Access Compliance Report Public Rights-of-Way (Curb Ramps)

Intersection ID: 19152 Main Street: E INDEPENDENCE BV Cross Street: VILLAGE LAKE DR Location: Ramp Type: PerpDiag Initial Pass/Fail: Fail **Overall Compliance: No Severity Score:** 22.5 ADA ID: F50D200EA704

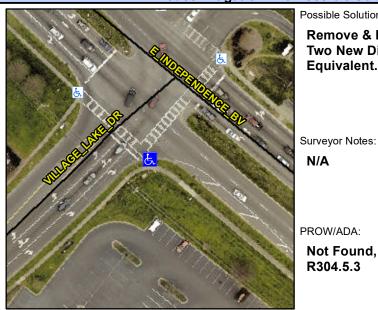
Not Found, R304.5.1, R304.2.2, R304.5.3

Compliance Description		Data	Compliance		Description	Data
N/A	Ramp Length (in)	83.0	No	Ramp	Slope (%)	8.8
No	Ramp Width (in)	42.0	No	Ramp	XSlope (%)	3.1
N/A	Flare Type LT	N/A	N/A	Flare	Type RT	N/A
N/A	Flare Slope LT (%)	N/A	N/A	Flare	Slope RT (%)	N/A
N/A	Flare Traversable LT?	N/A	N/A	Flare	Traversable RT?	N/A
N/A	Landing Length (in)	N/A	N/A	DWS	Provided?	N/A
N/A	Landing Width (in)	N/A	N/A	DWS	Contrast?	N/A
N/A	Landing Slope (%)	N/A	N/A	DWS	Length (in)	N/A
N/A	Landing X Slope (%)	N/A	N/A	DWS	Full Width?	N/A
N/A	Landing Curb? (Y/N)	N/A	N/A	DWS	Offset (in)	N/A
N/A	Shared Landing?	N/A				
N/A	Gutter Ponding?	N/A	N/A	Gutte	r Slope (%)	N/A
N/A	Gutter Lip Ht (in)	N/A	N/A	Gutte	r X Slope (%)	N/A
N/A	Painted X Walk1?	Yes	N/A	Paint	ed X Walk2?	Yes
	X Walk 1 Direction	To NE		X Wa	lk 2 Direction	To NW
N/A	X Walk 1 Width (in)	107.0	N/A	X Wa	lk 2 Width (in)	98.0
	X Walk 1 Slope (%)	0.9		X Wa	lk 2 Slope (%)	3.3
	X Walk 1 X Slope (%)	2.1		X Wa	lk 2 X Slope (%)	0.8

Possible Solutions: Remove & Replace Curb Ramp With Two New Directional Ramps or Equivalent.
